SUBJECT: Forwards addl info for 860702 application for amend to  
 License NPF-16 re spent fuel storage, per 861210 request.  
 Shipping cask Models NAC-1 & NLI-1/2 only casks that meet 25  
 ton Tech Spec limit for Unit 1 cask crane.

Re: St. Lucie Units 1 and 2  
Docket Nos. 50-335 and 50-389  
Spent Fuel Transfer

### REQUEST FOR ADDITIONAL INFORMATION FLORIDA POWER & LIGHT COMPANY ST. LUCIE UNITS 1 AND 2 SPENT FUEL TRANSFER BETWEEN UNITS PLANT, ELECTRICAL, INSTRUMENTATION AND CONTROL SYSTEMS BRANCH

Figure 1-1  
Spent Fuel Storage  
St. Lucie Unit 1

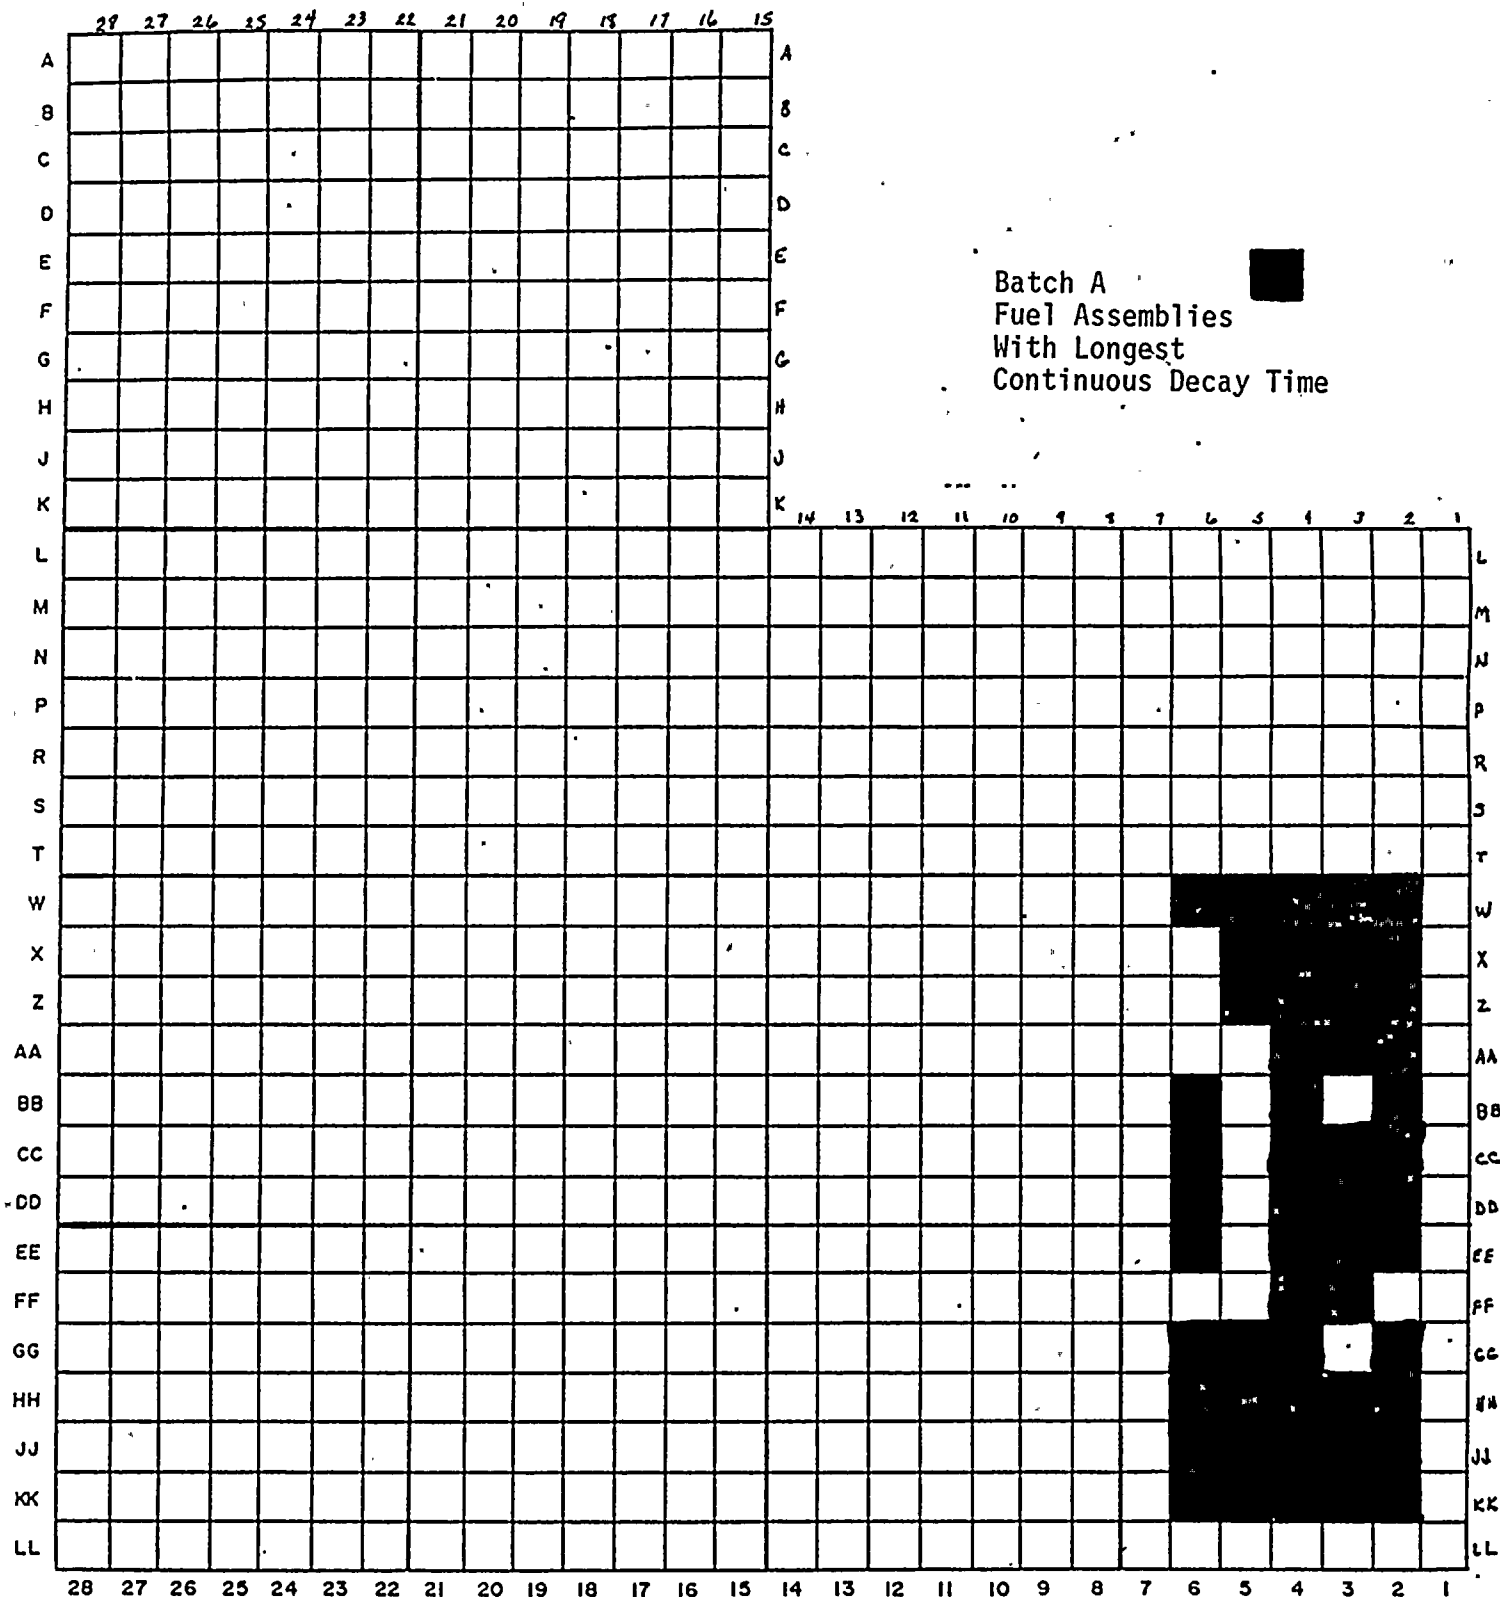
1. Provide further details regarding the Unit 1 SFAs to be stored in the Unit 2 SFP. The details should include number, type and age of existing SFAs to be transferred to Unit 2 and the SFA locations in the Unit 2 storage racks to be utilized. Also provide any necessary drawings to clarify your response.

Although the proposed amendment would not limit the number of SFAs that could be transferred to the Unit 2 SFP, it is expected that only 15 to 25 SFAs would be subject to transfer, should this option become necessary. Figure 1-1 shows the Unit 1 spent fuel pool with the Batch A assemblies indicated.

### UNIT NO. 1 & 2 - PARTIAL SITE PLAN

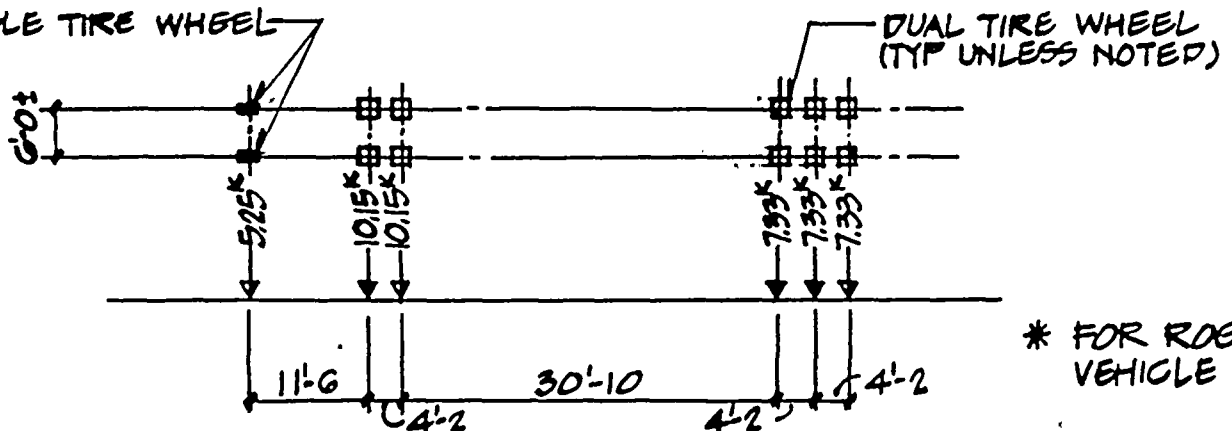
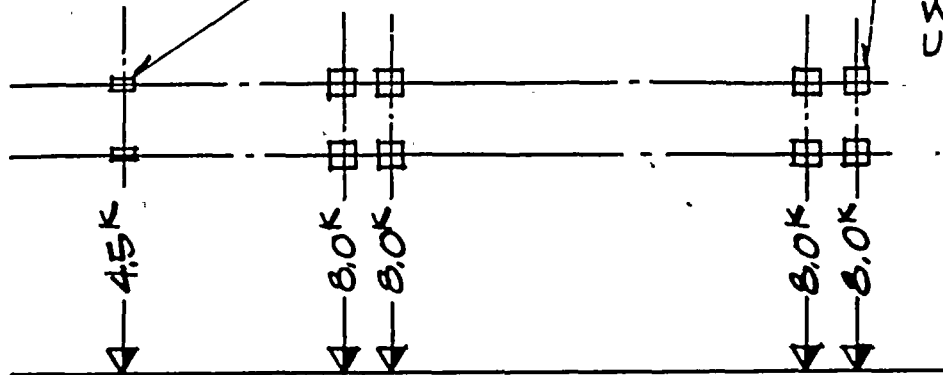
3. Provide a summary of the evaluation performed concerning the shipping cask load path between the units. This summary should include a discussion of the means utilized to confirm that safety related equipment including piping, components, and electric conduits that are located near the load path and those that are buried under the load path will not be adversely affected with regard to their capability to perform their intended safety functions during normal spent fuel transfer from Unit 1 to Unit 2 and in the event of an accident such as cask drop. Also, provide any necessary drawings to clarify your response.

The evaluation considered a spent fuel trans-shipment path starting at the Unit 1 cask loading area and traveling to the Unit 2 cask loading area as indicated in Figure 3-1. This path, in its entirety, coincides with a portion of the intermodal cask transporter path previously evaluated for effects upon underground structures and utilities. The spent fuel trans-shipment path road surface is paved with Portland cement concrete or asphaltic concrete.

The fuel elements to be transported will utilize a one element shipping cask having a maximum weight of 25 tons when loaded with the spent fuel assembly. Two transport vehicles were considered in the evaluation. Wheel loads for the two vehicles are shown in Figures 3-1 and 3-2. The reactions of the two transport vehicles were compared to the maximum reactions of the intermodal cask transporter that was previously evaluated. Since the reactions of the intermodal cask transporter are greater than the reaction for either of the two transport vehicles, the intermodal cask transporter evaluation is considered to be an enveloping evaluation.
